## PLANNING BOARD

Tuesday, June 9, 2026 at 4:30 PM  
City Hall, Room 209, 2nd Floor and  
Zoom

**To:** Chair Zamboni & Members of the Planning Board  
**From:** Sean King  
**Date:** June 3, 2026  
**Re:** 15 & 19 Cedar Street  
**Project ID:** PL-003553-2026  
**CBL:** 026 C015001, 026 C014001  
**Meeting Date:** June 9, 2026

Avesta Housing Corporation has submitted a Major Site Plan application for the construction of a five-story, 26,086 square-foot multi-family residential building at 15 & 19 Cedar Street. The proposed development includes 30 dwelling units, of which 100 percent would be deed-restricted affordable dwelling units, along with community spaces for the residents. The property is located in the RN-4 Residential Neighborhood zone. This application is being referred to the Planning Board for compliance with the City of Portland’s Land Use Code Site Plan Standards, Section 13.6.

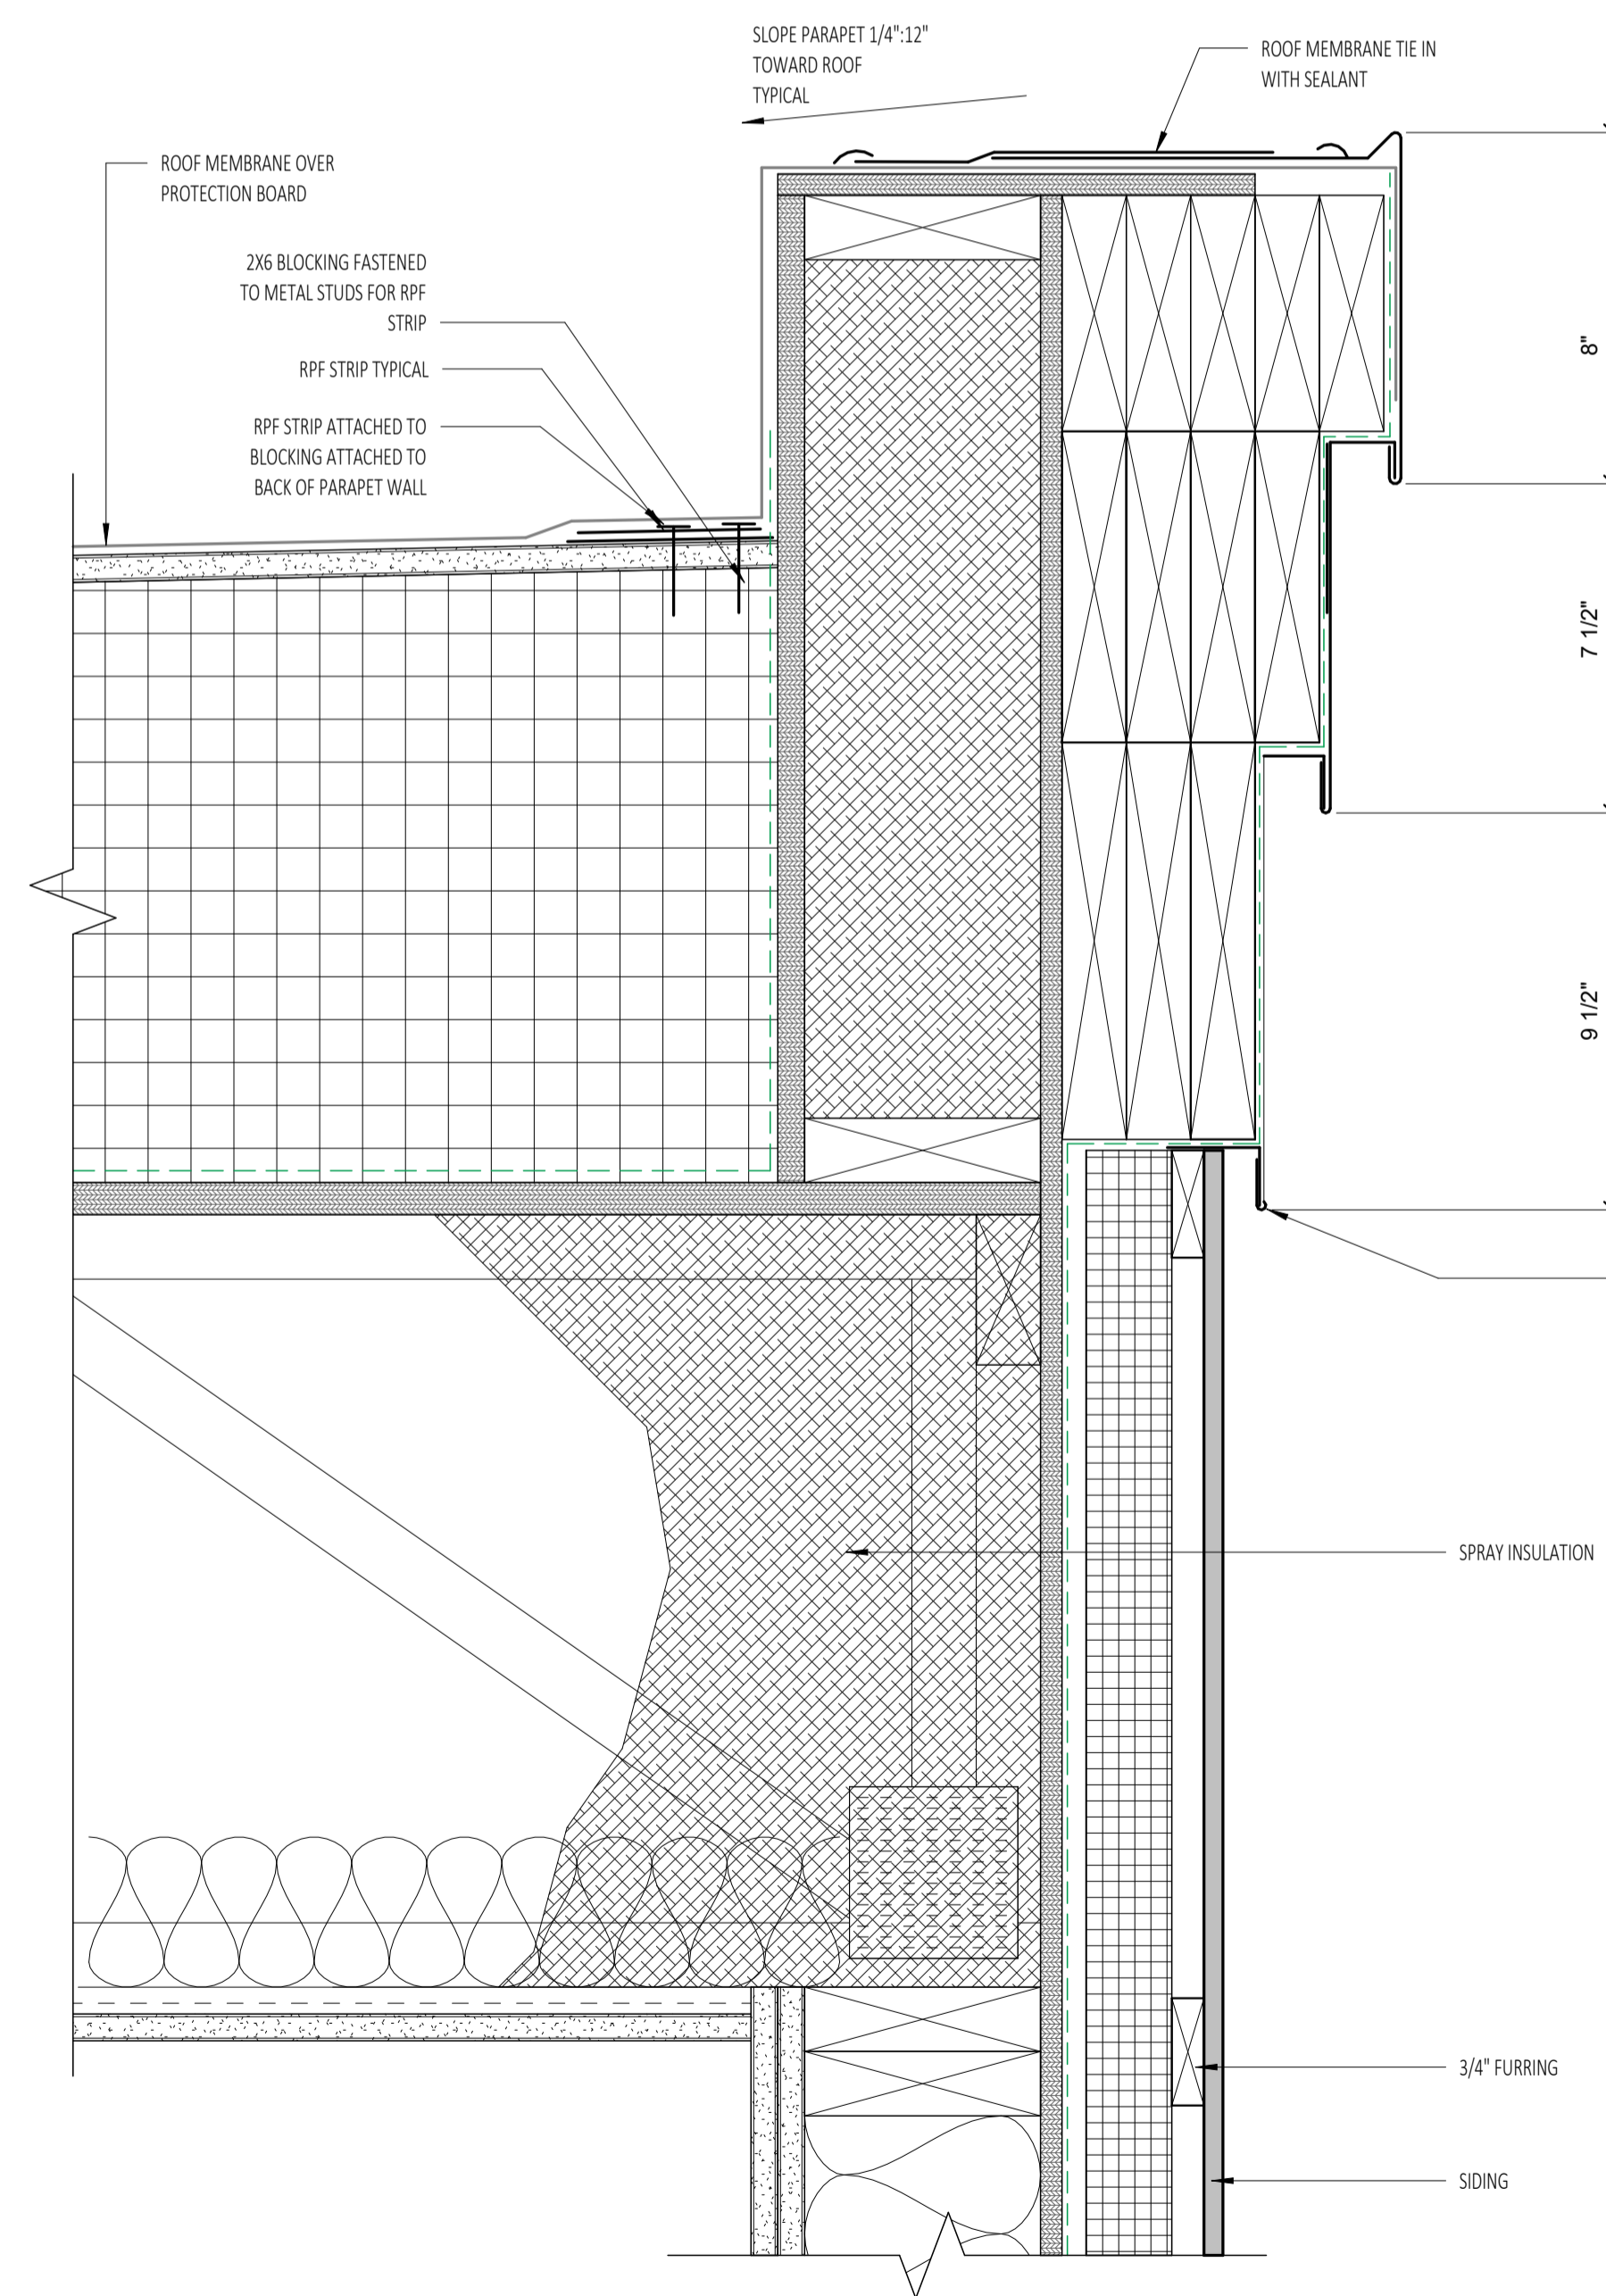
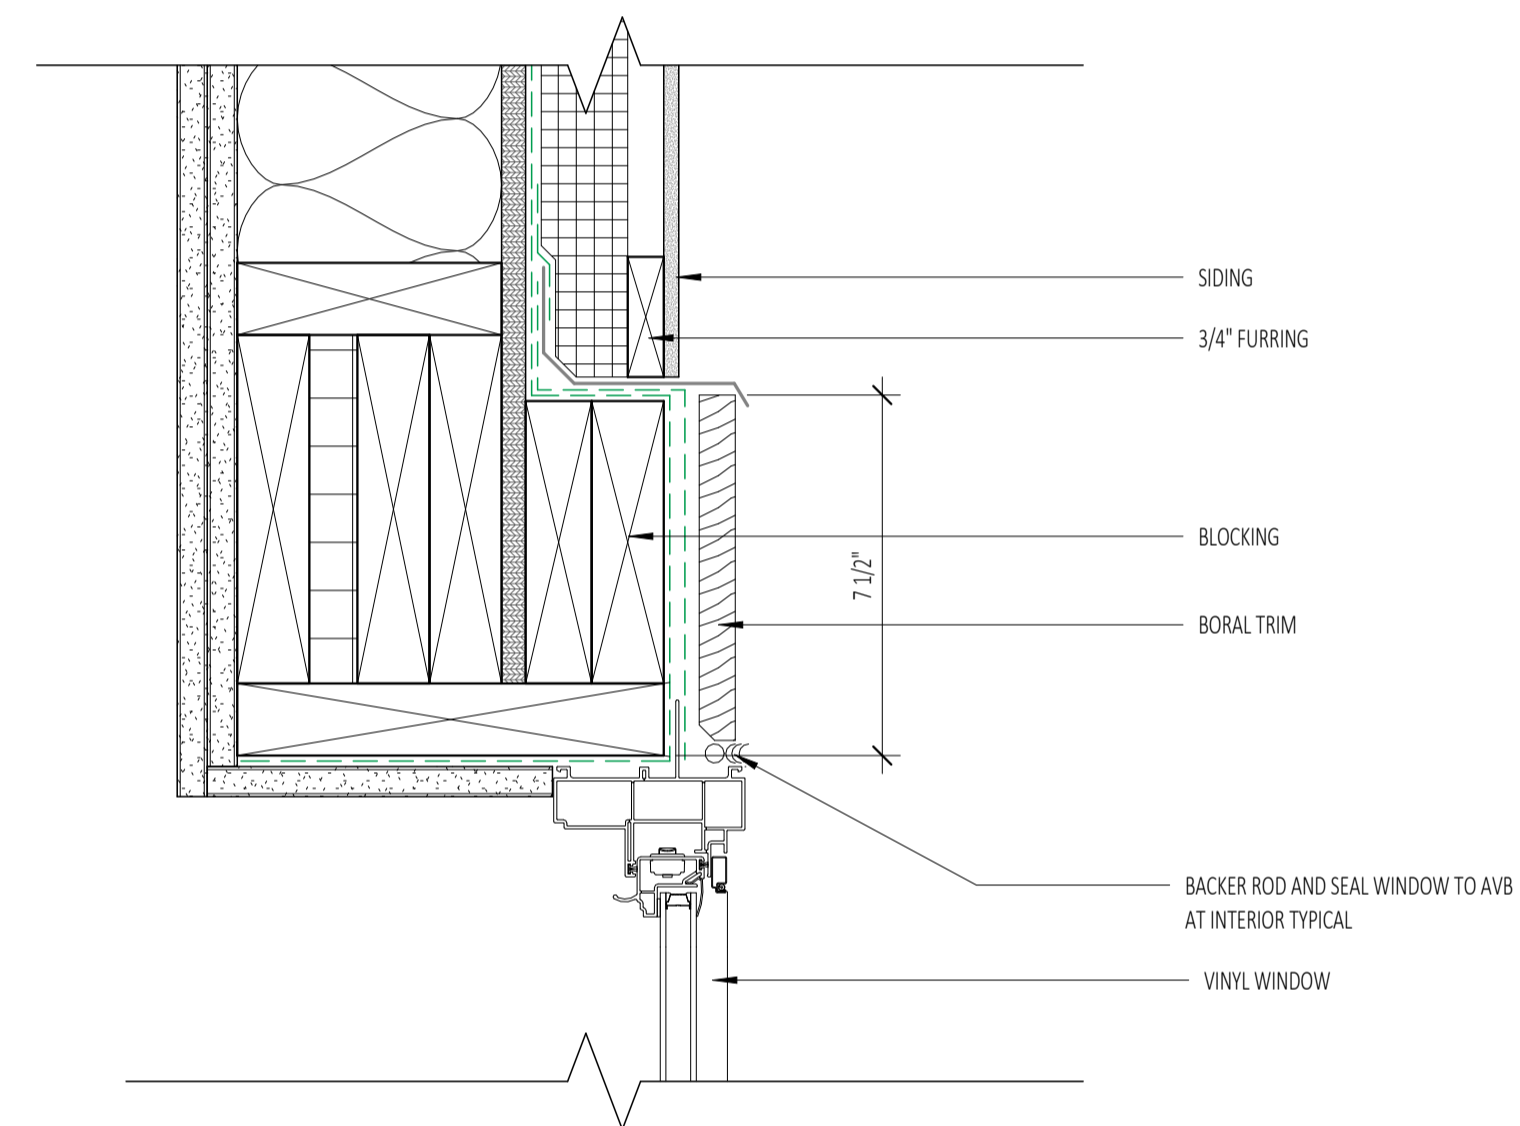
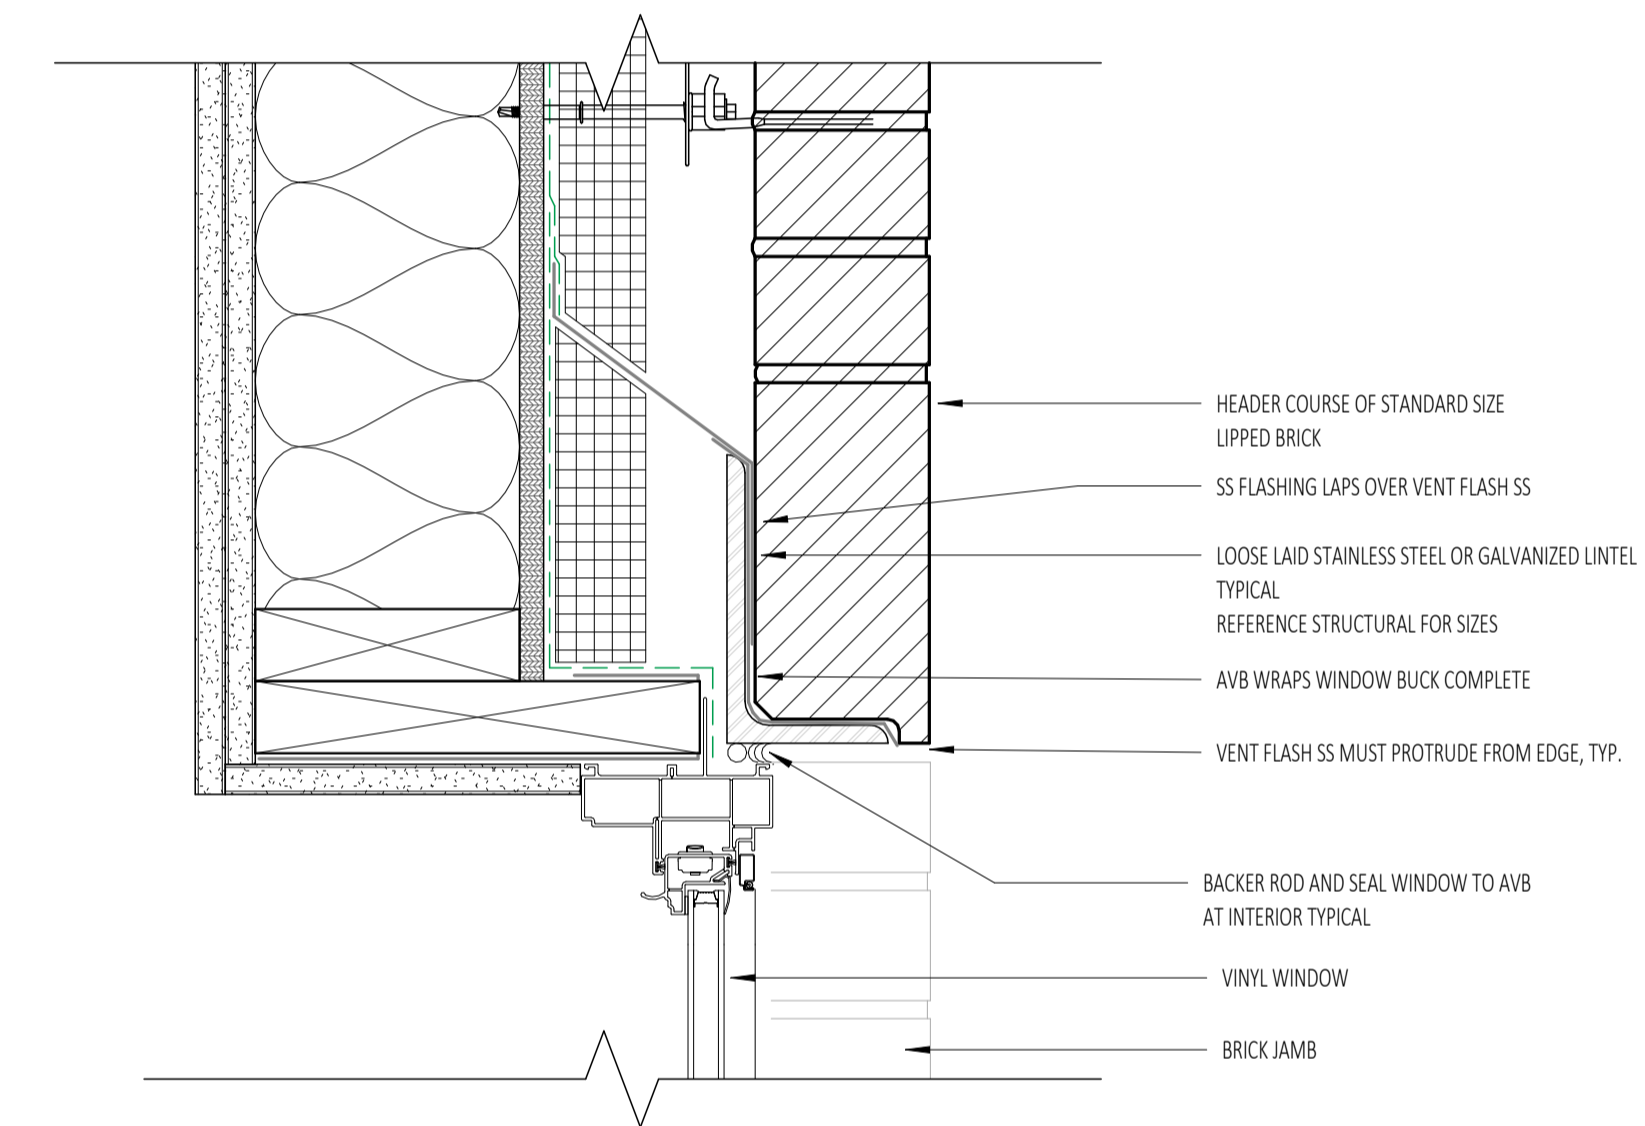
Staff has prepared a design review memo, attachment S4, with comments to provide greater visibility for the recessed entrance at Cedar Street and to specify exterior façade materials onto the architectural elevations.

The requested details have been added to Sheet A5.00. These include vertical window sill, head, and roof cornice details, as well as a horizontal detail addressing the corner trim condition.
